Document ID: IK0800442
Revision: 1
Created: 7/11/2013
Last Modified: 3/10/2014
Author: Patrick Gotschall

Title: Auxiliary Battery Box - Cover Difficult to Remove

Applies To: Prostar or any vehicle with Feature Code 0008XGG (auxiliary battery box)

Figure 1 - Replace bolts causing the interference

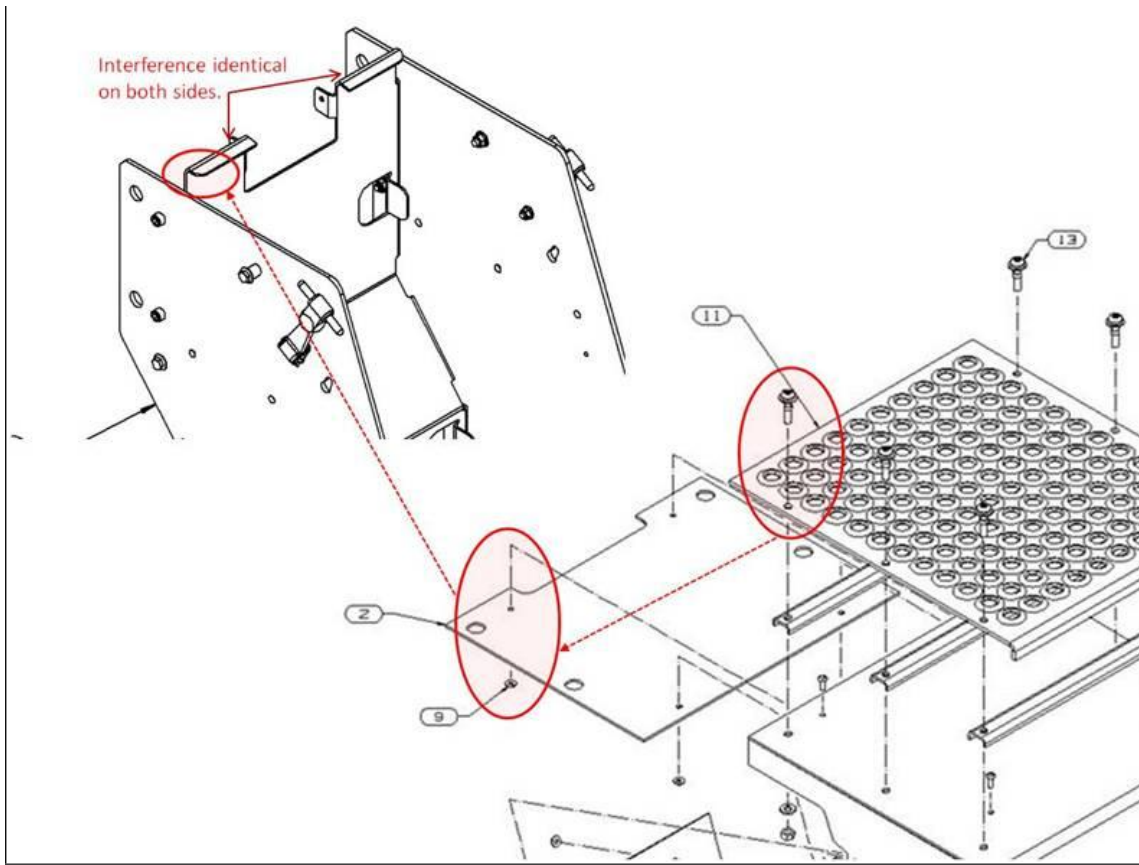
An interference condition can occur between cover bolts or step plate and a flange on the back plate of the battery box. This document describes the condition and remedy of replacing the existing bolt with a shorter bolt to eliminate the interference condition.

Replace 2 - 3804756c1 M8x35mm bolts indicated as item 13 in Figure 1 w/ 2 - 3588153c1 M8x30 bolts.
